Fire statement form

Application information	
1. Site address line 1	Crown Street Phase 3
Site address line 2	Great Jackson Street
Site address line 3	
Town	Manchester
County	Lancashire
Site postcode (optional)

Meeting minutes

Meeting: Great Jackson Street, Crown Street Phase 3 and Plot D – Fire Safety Design Review Date: 30/11/2022
Time: 10.30am

Figure 1 – Towers C7 and C8 indicative core arrangement

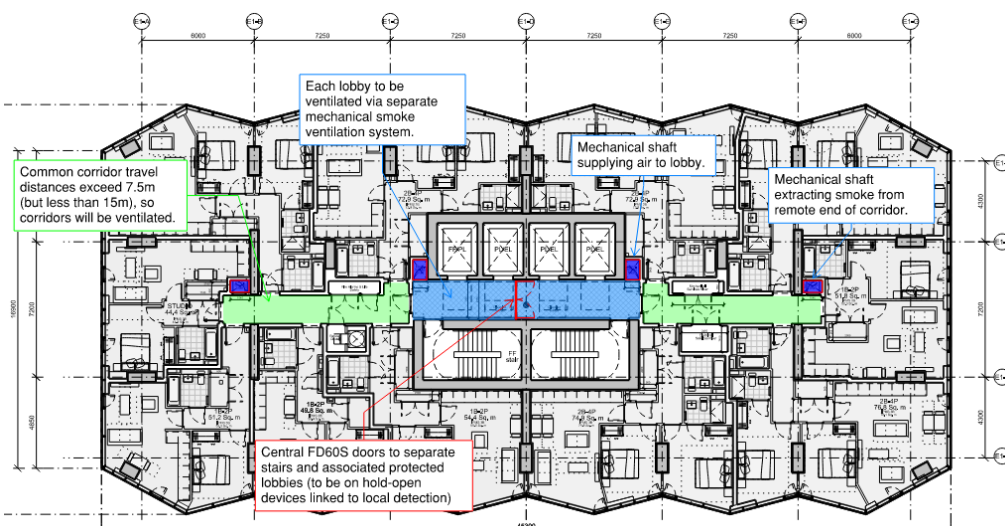
3.2	GMFRS and MCC BC confirmed that they will require the doors separating the lobbies of the adjacent stair cores in each building to be retained as currently shown (regardless of what the final recommendations of the updated BS 9991 are) and requested that these doors are provided with hold-open devices, linked to localised smoke detection, so that they are not 'damaged' through daily use (i.e. held open in all but fire conditions).

3.3	AS outlined ventilation provisions for towers C7 and C8 as follows: - Each stair/lift lobby will be ventilated by means of a single mechanical smoke extract shaft, activated by smoke detection within the associated common corridor and lobby (i.e. system in each half of floor activates independently). - Each extract shaft system will incorporate pressure sensors and a fan inverter, so that extract rates can be ramped up and down to prevent excessive pressure differentials. - Replacement air to ventilated lobby will be drawn from leakage around stair and lift doors - AOV to be provided at head of stair and vents may be required to lift shafts to increase background leakage (TBC as part of system design). - As the common corridor travel distances do not exceed 7.5m, they will not be ventilated, in line with BS 9991 guidance for ventilated sterile lobby arrangement.

GMFRS confirmed acceptance of ventilation proposals on the basis that the mechanical smoke ventilation system designs will be demonstrated to not create adverse pressure

differentials (that may result in door opening difficulties) and will be modelled to demonstrate continued operation when subject to adverse wind conditions. CFD modelling and cold-smoke testing will be provided by the specialist designer/sub-contractor.

3.5	MCC BC noted their preference for a pressurisation system in high-rise buildings, but acknowledged that the proposals as presented appear to comply with the draft BS 9991 guidance. Cross-reference to the final issue of the new BS 9991 (when released) would be required to ensure the solution is still compliant.

Figure 2 – Towers E1 and E1 indicative core arrangement

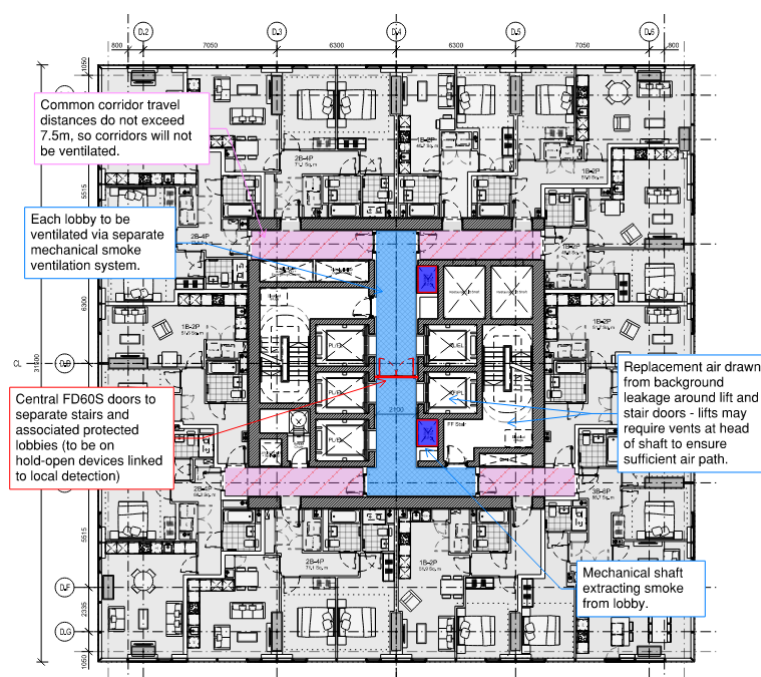
AS outlined ventilation provisions for towers E1 and E2 as follows:

- As common corridor travel distances will exceed 7.5m (but not 15m), they will each be ventilated, by means of a single mechanical smoke extract shaft provided at the end of common corridor (i.e. remote from the stair core).
- Each stair/lift lobby will be provided with a single mechanical air inlet shaft, which will provide replacement air for the corridor extract shaft and maintain a net air flow away from stair core.
- The door between the stair/lift lobby and common corridor will open into the corridor to enable self-balancing of pressure differentials (i.e. door may be pulled open slightly), if necessary (TBC as part of system design).
- AOV to be provided at head of stair.
- Ventilation provisions will be activated by smoke detection within the associated common corridor and lobby (i.e. system in each half of floor activates independently).
